February 2, 2020

Re: Middle Island POA Cape Creek Marina Floating Docks As-Built Structural Assessment

MIDDLE ISLAND MARINA DOCK CALCULATIONS - 2-2-2020

MIDDLE ISLAND MARINA DOCKS AS BUILT CONFIGURATION: Cross Section

Figure 2-6. Single pole load and deflection test.

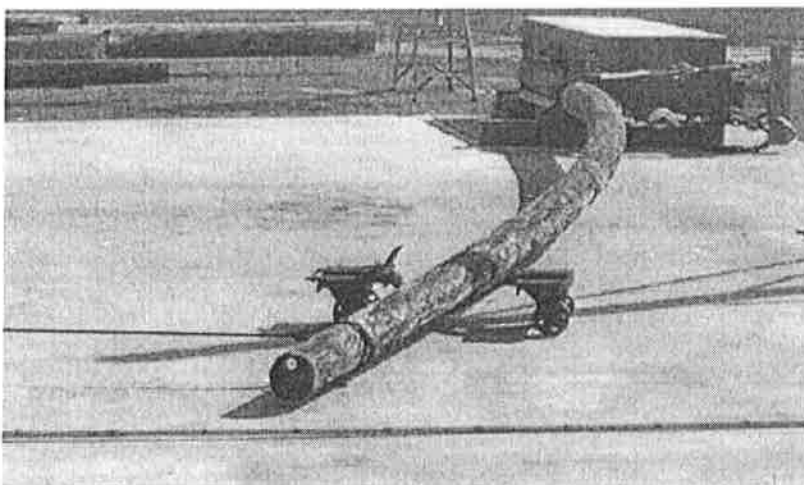
We rarely see utility poles or marina piles bent this much, but poles/piles can take a lot of bend.

Project Name: Occupied Docks 72 mph Wind, 1.5' Waves, 2 FPS Current/Landward Piles at Low Tide

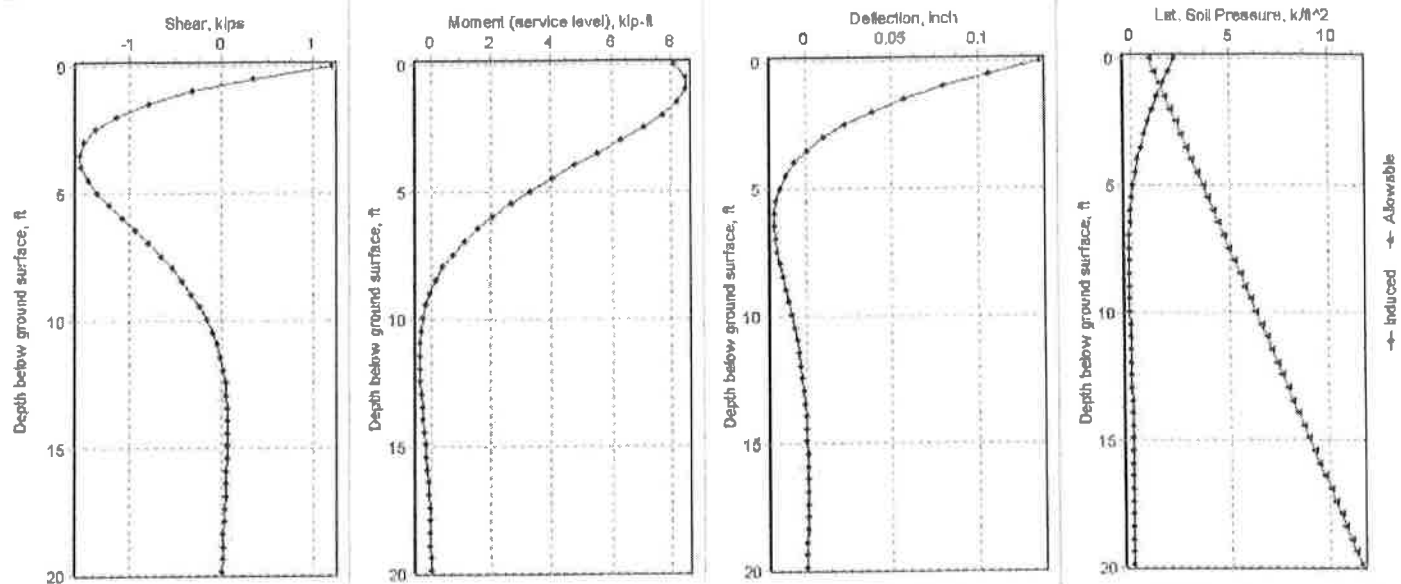
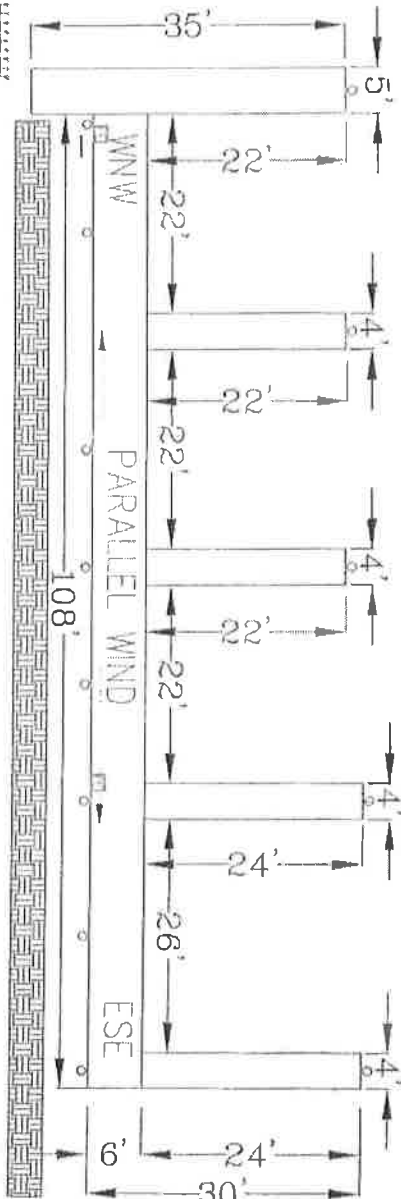
Maximum Deflection is 0.33 in at 0.00 ft
 Maximum Moment is 8.56 k-ft at 0.50 ft
 Maximum Shear is -1.98 kips at 2.48 ft
 Pier/Pile Tip Movement is 0.00 in at the bottom (9.90 ft)

Maximum Deflection is 0.14 in at 0.00 ft
Maximum Moment is 8.48 k-ft at 1.00 ft
Maximum Shear is -1.54 kips at 3.48 ft
Pier/Pile Tip Movement is 0.00 in at the bottom (19.90 ft)

For the With Boats, 72 mph (Category 1 Hurricane) load case, with 1.5' waves and 2 FPS current, the calculated deflection for the as built piles at mudline is 0.39" for the waterward and 0.33" for the landward piles. If the landward piles were 45' in length 14" diameter at 3' from the end, the deflection at mudline drops to 0.14". For cyclic loading, references indicate that the deflection values should be doubled. So, we are talking about in a Cat 1 Hurricane $\frac{3}{4}$ " of predicted deflection as-built, and $\frac{5}{16}$ " with 45' piles without adding the extra wind lateral load and moment due to the 5' taller pile height. So maybe $\frac{3}{8}$ " of predicted pile movement difference.

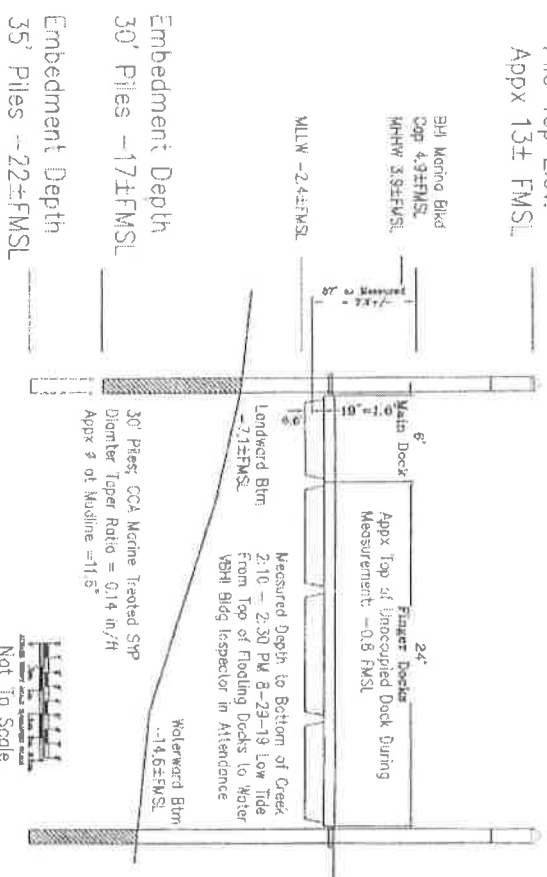
Embedment Depth	30' Piles -17±FMSL	Embedment Depth	30' Piles -22±FMSL
30' L1 = 7.9'	-8.7 FMSL	8.3'	35' W1 = 13.0'
30' L2 = 9.3'	-10.1 FMSL	6.9'	35' W2 = 15.0'
35' L3* = 8.5'	-9.3 FMSL	12.7'	35' W3 = 14.1'
30' L4 = 7.9'	-8.7 FMSL	8.3'	35' W4 = 13.9'
30' L5 = 6.8'	-7.5 FMSL	9.5'	35' W5 = 13.2'
30' L6 = 6.2'	-7.0 FMSL	10.0'	
30' L7 = 4.9'	-5.7 FMSL	11.3'	
30' L8 = 3.8'	-4.5 FMSL	12.5'

Sum of Pile Embedments = 116.3'

/13 total piles = 8.95' avg Embed

L3 is a 35' pile per Tommy Perry See Dock Layout plans for pile numbering (May be L2)
